MT/5986/sk

15th March 2024

Re: Interbridges Site, New Brighton Road, Emsworth (LPA Ref APP/24/00025)

Bellamy Roberts has been instructed by PNH Properties Ltd to prepare a written response to the consultation comments received from the Highway Authority, dated 22nd February 2024. In summary, the Highway Authority has recommended refusal of the application relating to the achievable visibility at the access and swept path analysis. The Highway Authority comments are enclosed.

DRAWN BY MB	DESIGN BY -	CHK BY MT
DATE 03/11/23	DRAWING No. 5986 / 201	
SCALE 1:250 @ A3	REV No. B

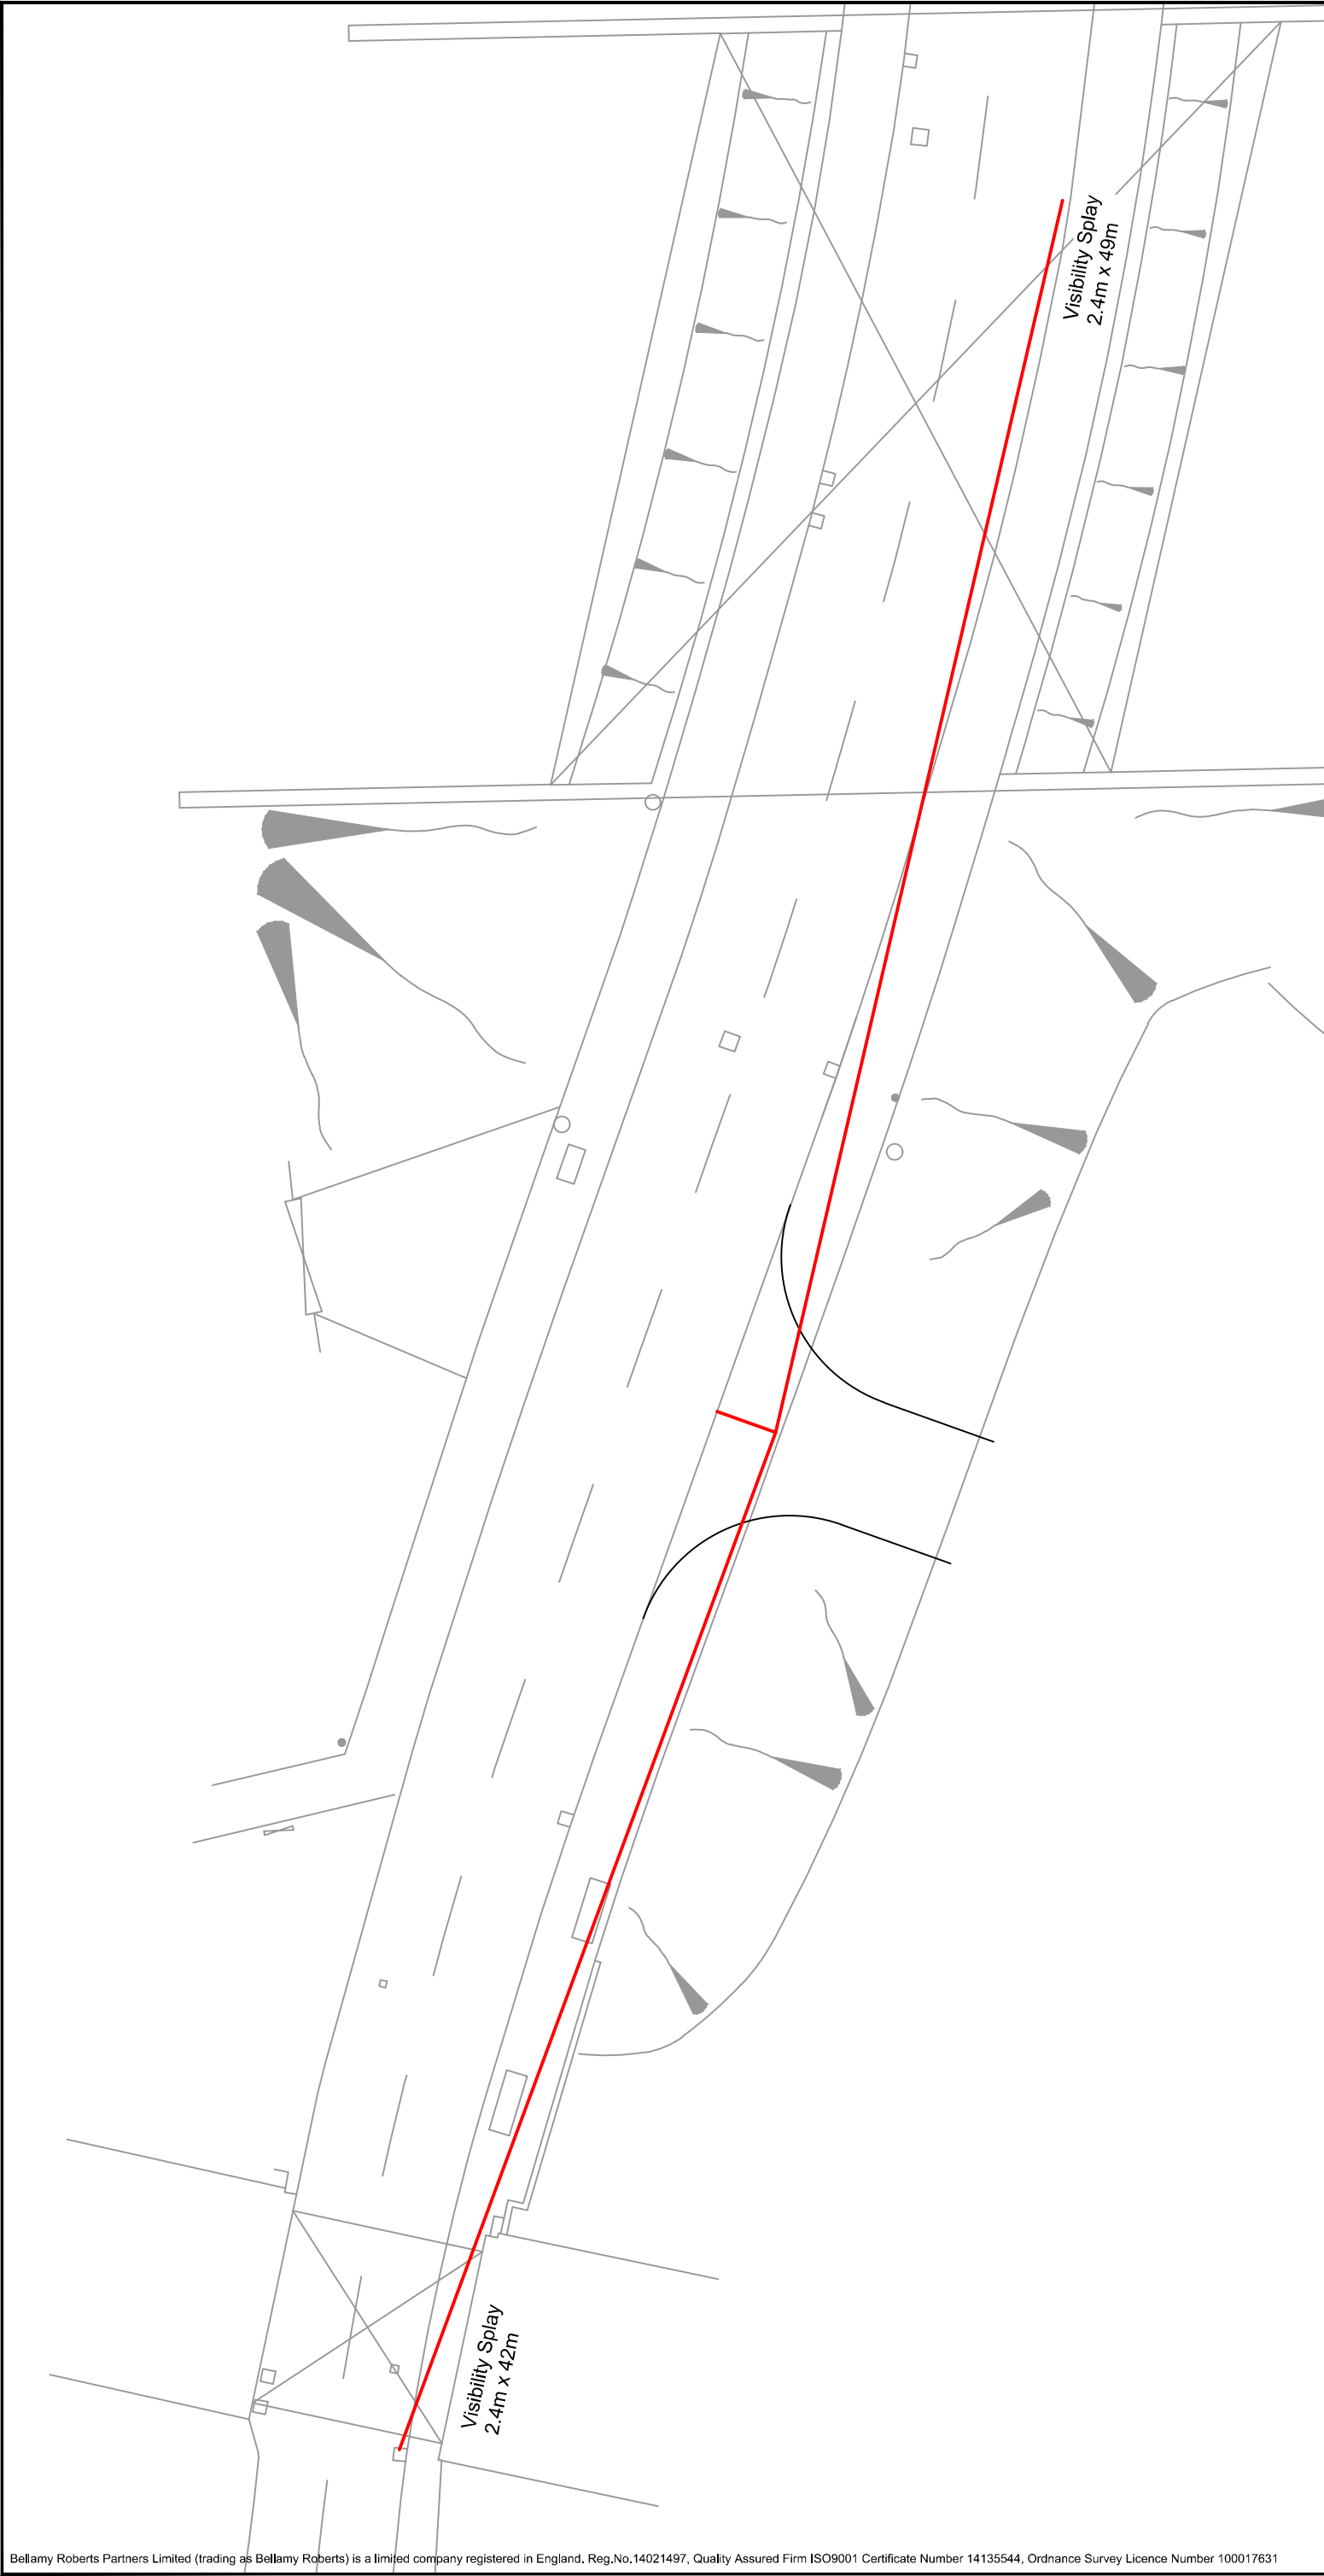
The Highway Authority has stated that “*all turning movements should be undertaken within the appropriate side of the carriageway*”. This is contrary to both Manual for Streets and DMRB guidance which advises that it is entirely appropriate for vehicles to use the full width of the carriageway, if the manoeuvre is undertaken on an infrequent basis.

In this instance, the proposed access is to allow for maintenance of the land within the site only. The land owner has confirmed a small tipper will be the largest vehicle that will enter/exit the site.

Such a vehicle will access the site on a very infrequent basis, approximately 6 times per annum, and would not meet any other vehicle either entering or exiting the site. There will be no instances where the tipper vehicle will be required to pass a car, for example.

Nevertheless, and to address the concerns raised by the Highway Authority, the geometry of the proposed access has been revised to ensure the small tipper vehicle can undertake all movements within the appropriate side of the carriageway.

The revised swept path analysis is enclosed.

The vehicle has been tracked at a speed of 5kph which is entirely representative of the speed this manoeuvre would be undertaken at. When entering and exiting the site, the vehicle would come to stop before turning left in/out or right in/out.
